UNITED STATES PATENT AND TRADEMARK OFFICE

10/790,551

Office Action Summary

DETAILED ACTION

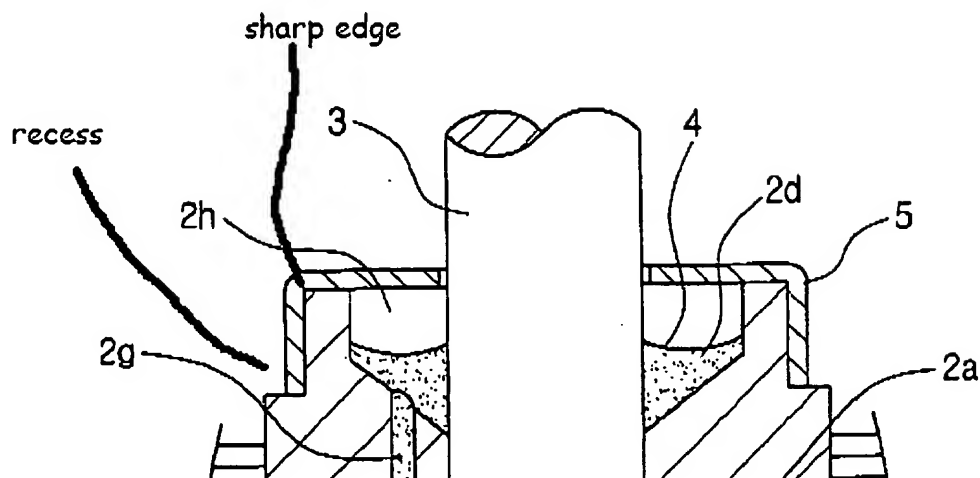
Kishi discloses a hydrodynamic bearing and motor system comprising:

- a shaft (3)

- a bearing sleeve (2), said bearing sleeve having an inner cylindrical bore, the shaft inserted into the bore.

- a bearing gap (2a, 2b) formed between the shaft and bearing sleeve, filled with lubricating oil (4)

- a shield (5) enclosing the bearing sleeve

wherein the bearing sleeve further comprises a recess having a sharp edge and where the shield is secured to the bearing sleeve by being pressed against the sharp edge of the recess.

Regarding claims 3 and 10, at least one bearing element (2i) is mounted on the shaft.

Regarding claims 4 and 11, the bearing and spindle motor have a lubricating oil reservoir (2d, 2e, 2f), and the shield is secured within the recess of the bearing sleeve at a position that is distanced from the lubricating oil reservoir.

Regarding claims 5 and 12, the shield is secured at a position on said end surface of the bearing sleeve that is distanced from the bearing gap, and the shield does not contact the lubricating oil.
